Standard Development Timeline

Description of Current Draft

1. **Title:** Protection System Coordination for Performance During Faults
2. **Number:** PRC-027-1
3. **Purpose:** To coordinate Protection Systems for ~~Interconnected~~Interconnecting Elements, such that Protection System components operate in the ~~desired~~intended sequence during Faults.
4. **Applicability:**

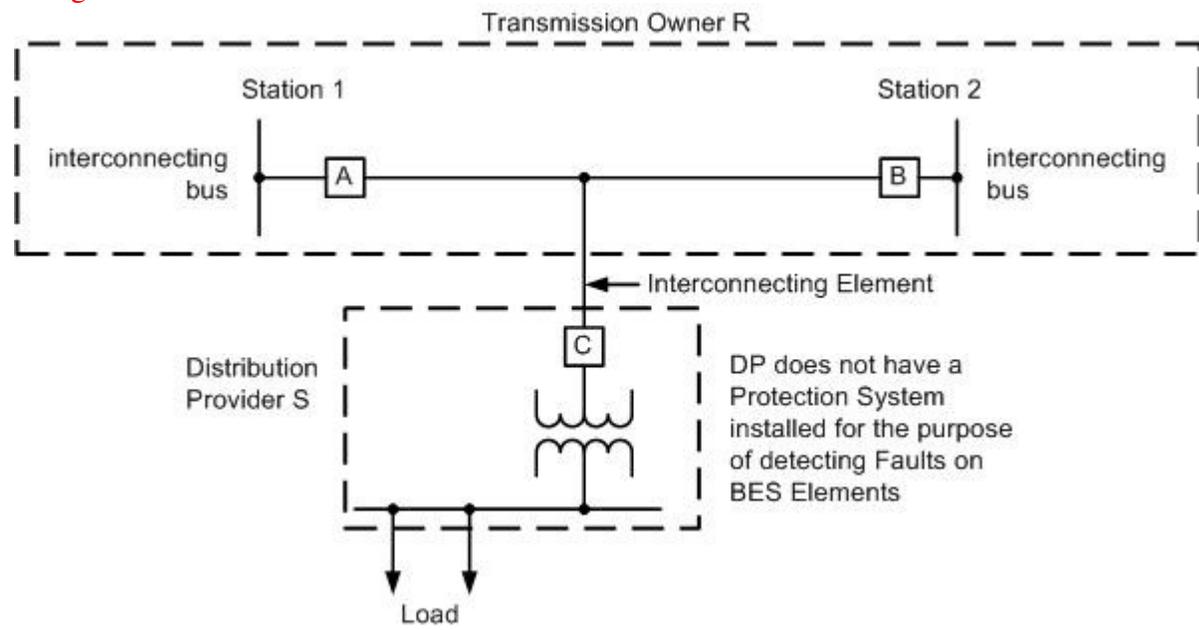
The configuration above, ~~the Interconnected Element between the Transmission Owner and is an example excluded from this standard because the Distribution Provider is the transmission line or tap between the line and Breaker C.~~

~~Note: No specific PSCS is required per this standard for this example since the S does not own Protection System at the Distribution Provider's substation is not Systems installed for the purpose of detecting Faults on BES Elements.~~

Figure 5

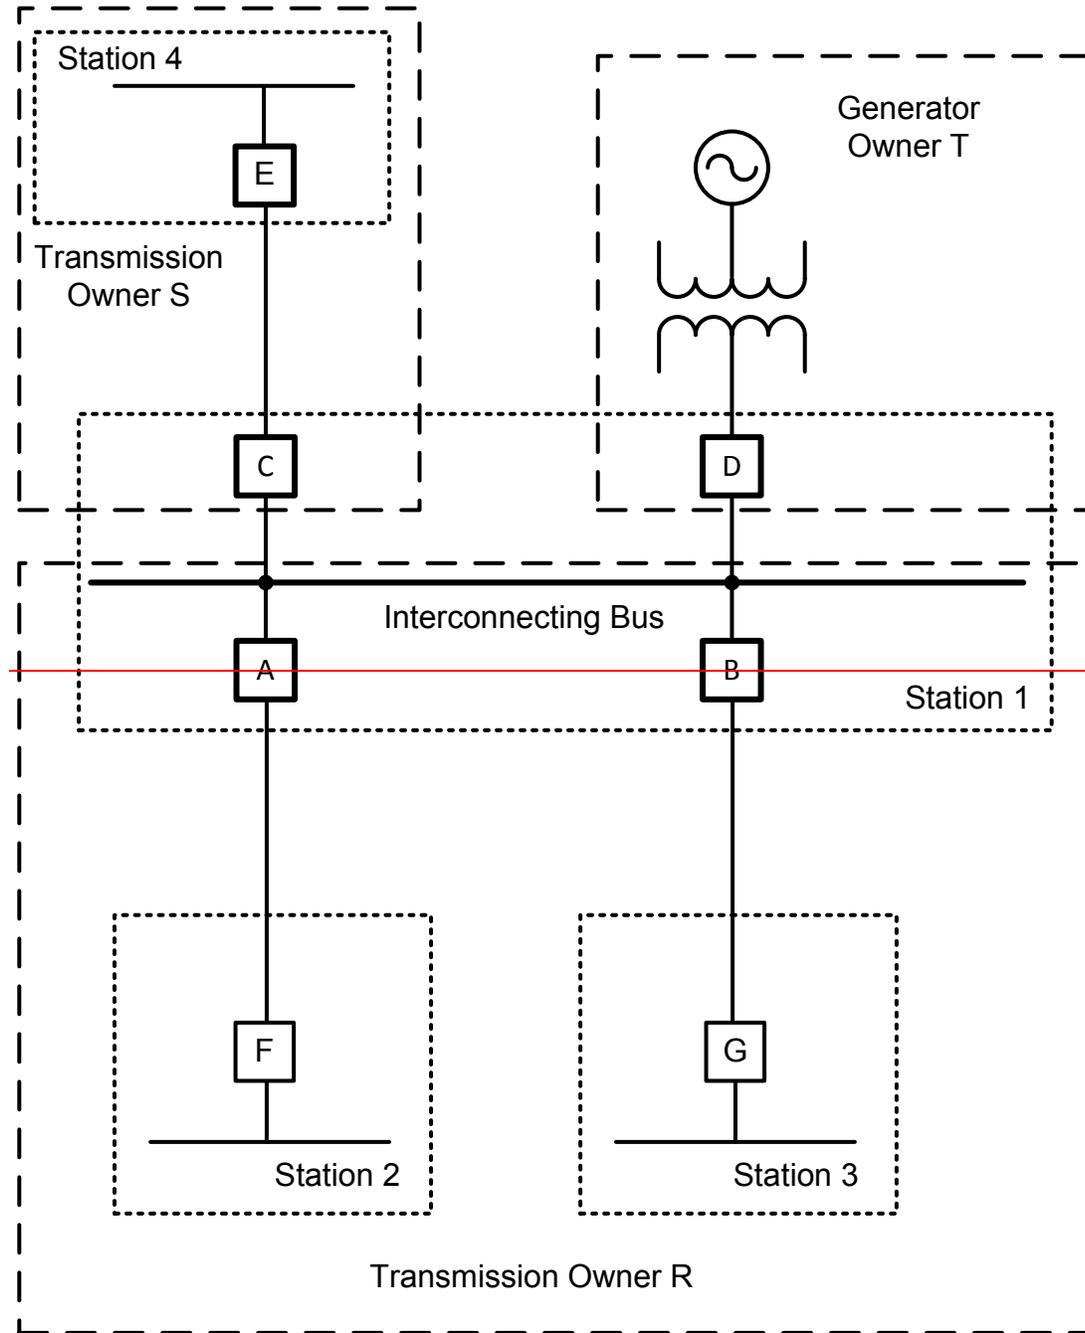
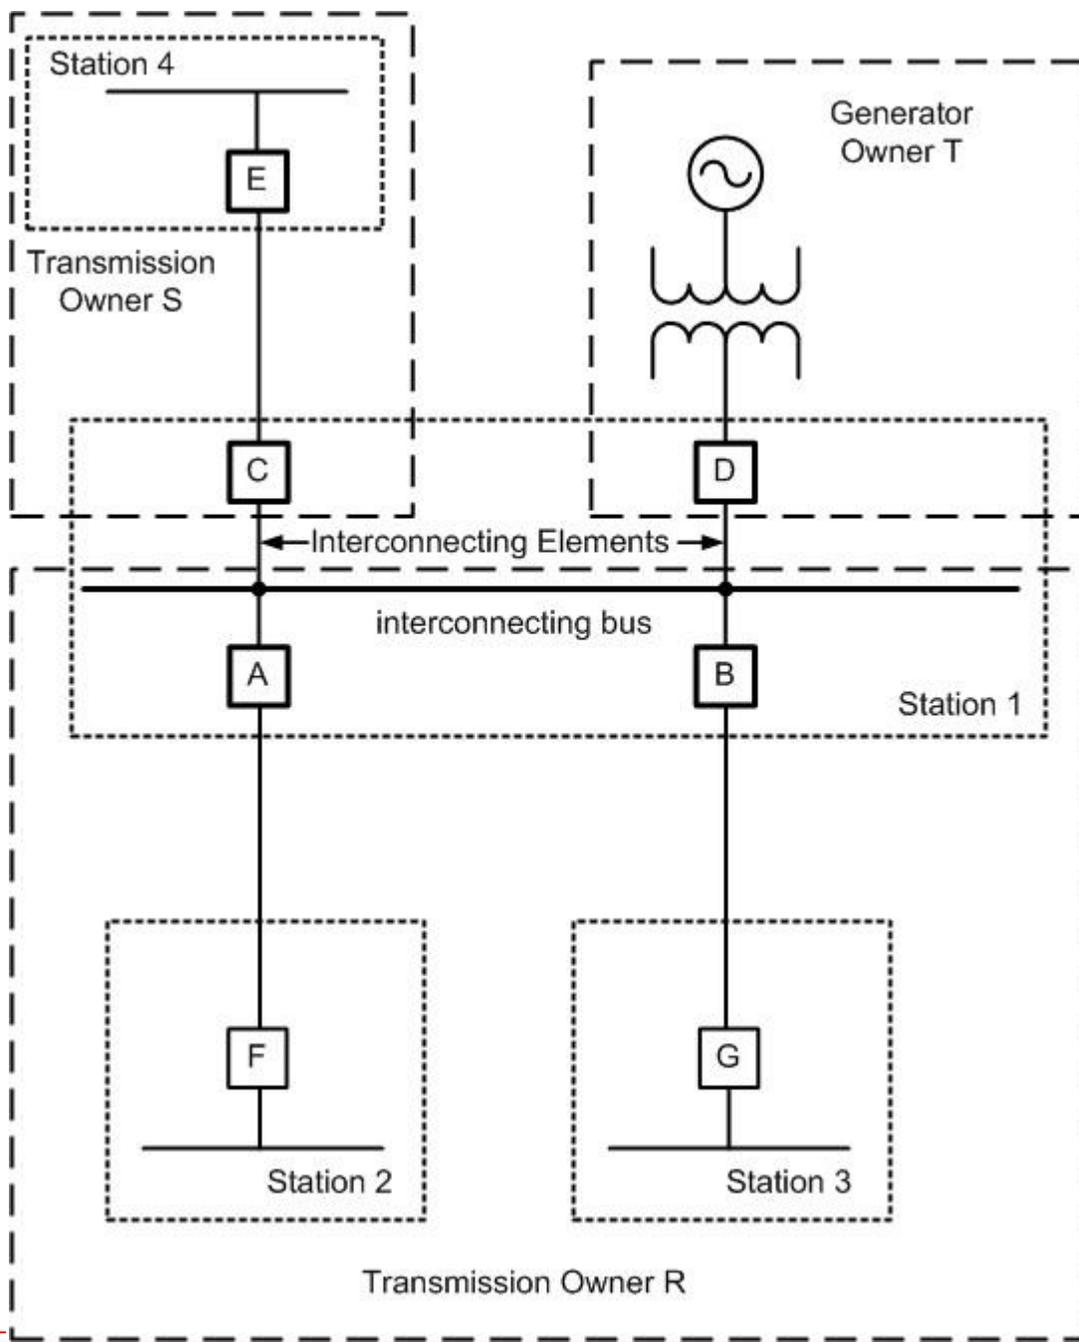
Figure 5 above, illustrates the ~~Interconnected Element~~ Interconnecting Elements between the Transmission Owners R and S and Generator Owner T ~~is the common Transmission bus.~~ In this example, Transmission Owner S and Generator Owner T are not directly ~~interconnected~~ interconnecting to each other at Station 1. All direct interconnections are between Owner R and each of the other Owners connected to the common bus at Station 1.
